Curraghinalt Project, County Tyrone, Northern Ireland

Prepared for Dalradian Gold Limited

Guide to the Planning Application
Second Addendum
October 2020

Figure 6.1: DSF development sequence showing the starter berm and revised shape

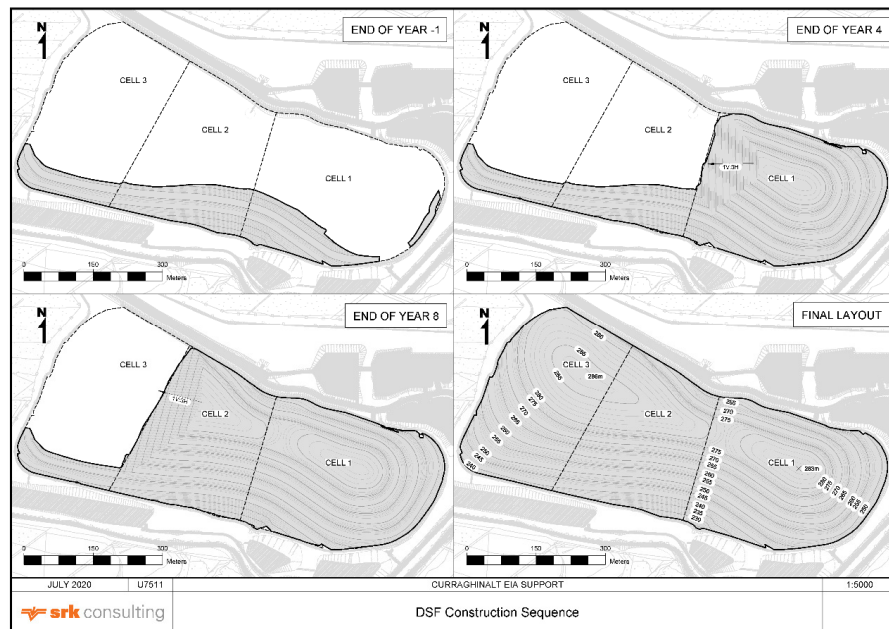
- 6.1 The main change since the 2019 submission has been the adjustments to the DSF design.
- Refinement of the shape to blend with surrounding landforms including a slight shift northward and steepening of the slope on the north side of the DSF to maintain the storage capacity of 4.8Mm³;

- Improvement of underdrainage;
 - Provision of more detail on the engineered cover design for the DSF (vegetated soil overlying bentonite-amended soil layer on external slopes).

- 6.2 Improvements to the internal DSF drainage are described Section 2.2 of the Second Addendum to the ES.
- 6.3 As shown in Figure 6.1, The DSF is designed as three cells, enabling each cell to be closed, restored and revegetated sequentially. The starter berm will effectively form the front (south) face of these cells, and will be in place, and planted before cell one (the easternmost cell) is used. Operations and machinery to the north of the starter berm will therefore be partly screened by this landform and vegetation.
